F/22/93194 Ageas development

Ecology Comments 16.11.23

Northern area of residential parcel (drainage strategy sheets 2, 1)

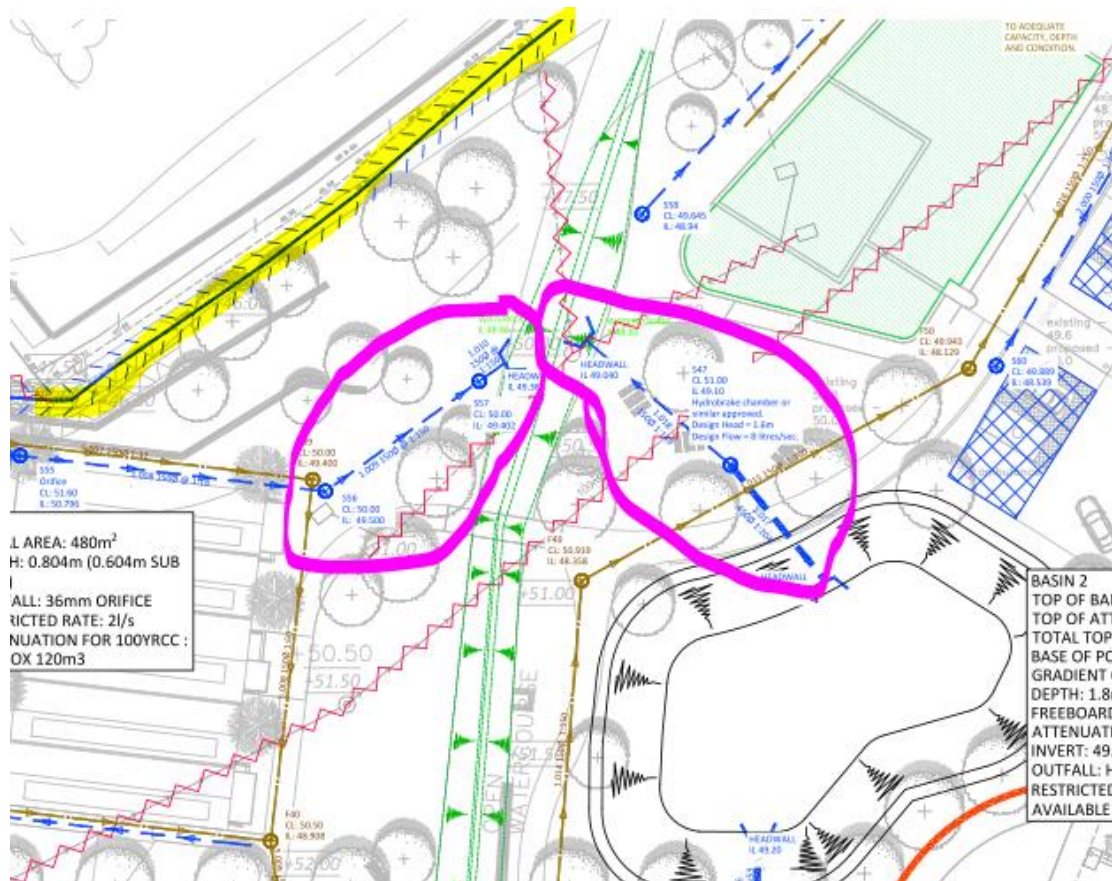
Provided both the attenuation basin and pervious paving are designed to function effectively to filter all of the receiving surface water runoff, then this satisfies the SuDS manual criteria regarding WQ. However, EBC's Policy DM7 requires a further two forms of treatment of the surface water prior to discharge from the site (three forms in total) which previously has been agreed to be provided through the modification of the existing downstream ponds/ lakes. These modifications must form part of the drainage proposals and must be shown to be capable of acting as effective filtration components.

As source control is limited in the scheme, the design of Basin 2 is crucial. A sediment trap at the inlet end of the basin is required to enable easier maintenance to ensure the effective working of the basin to maintain the WQ of the discharge.

The pervious paving will receive run off from impermeable areas several times its size. Therefore, the levels and flow paths within the pervious paving must be designed to ensure sufficient filtration is provided.

The underground pipe network should be minimised as much as possible. Could these two pipes circled pink below become open surface channels?

As the upstream culvert of the Telegraph Brook will be realigned, the highlighted stretch of watercourse above will no longer take upstream flows and will only take very localised runoff. It may also act as a backwater dependent on its bed levels and the water levels in the realigned and retained connected stretches of the Telegraph Brook.

Wellbeing centre (drainage strategy sheet 5)

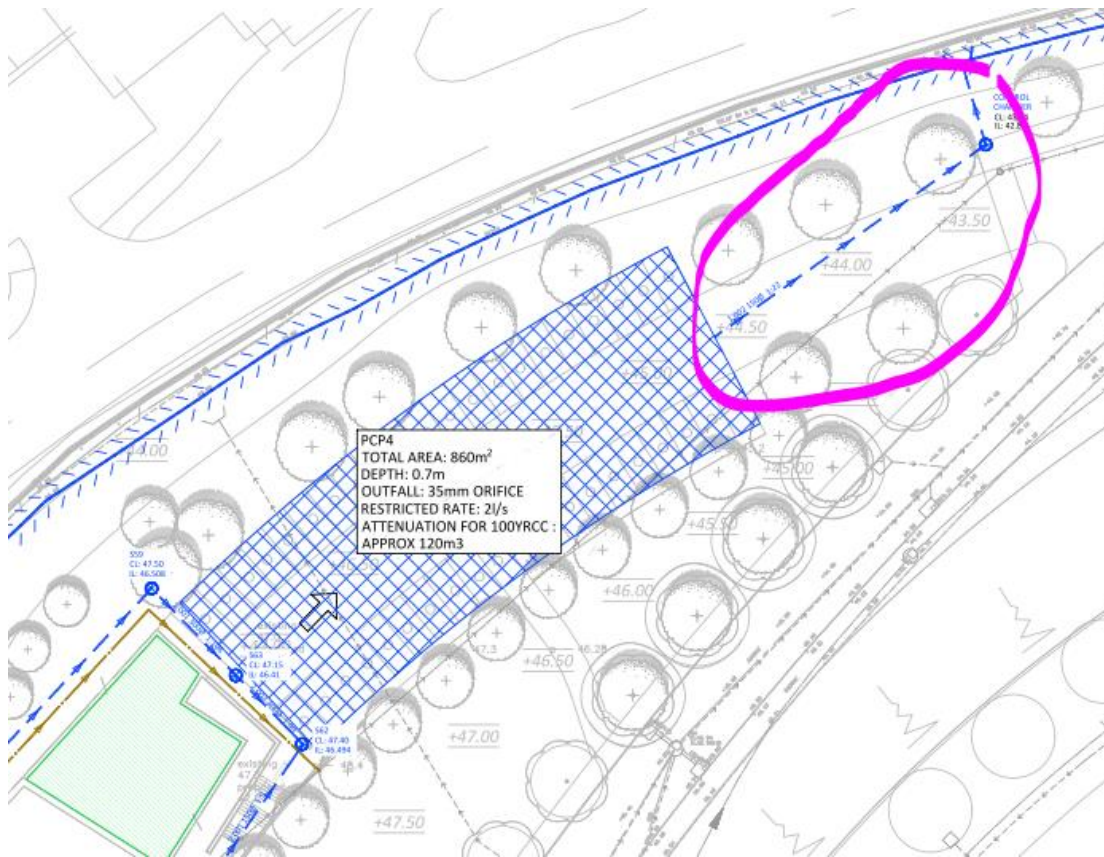
The green roof will provide good interception and run off will enter the adjacent pervious paving of the car park prior to discharge into the Telegraph Brook providing one form of filtration for the car park.

This level of filtration satisfies the SuDS manual criteria regarding WQ. However, EBC's Policy DM7 requires two further forms of treatment of the surface water prior to discharge from the site (three forms in total) which previously has been agreed to be provided through the modification of the existing downstream ponds/ lakes. These modifications must form part of the drainage proposals and must be shown to be capable of acting as effective filtration components.

The underground pipe network should be minimised as much as possible. Is there scope to change the pipe circled pink below to an open surface channel?

New hotel (drainage strategy sheet 6 or 8)

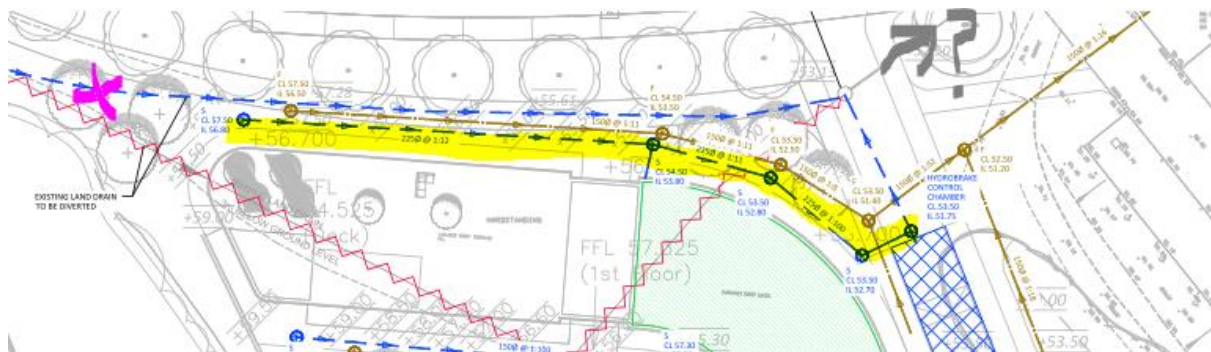
Drainage from the roof of new hotel and pedestrianised areas will pass through pervious paving (with storage tank underneath) prior to discharge to the realigned Telegraph Brook.

This level of filtration satisfies the SuDS manual criteria regarding WQ. However, EBC's Policy DM7 requires two further forms of treatment of the surface water prior to discharge from the site (three forms in total) which previously has been agreed to be provided through the modification of the existing downstream ponds/ lakes. These modifications must form part of the drainage proposals and must be shown to be capable of acting as effective filtration components.
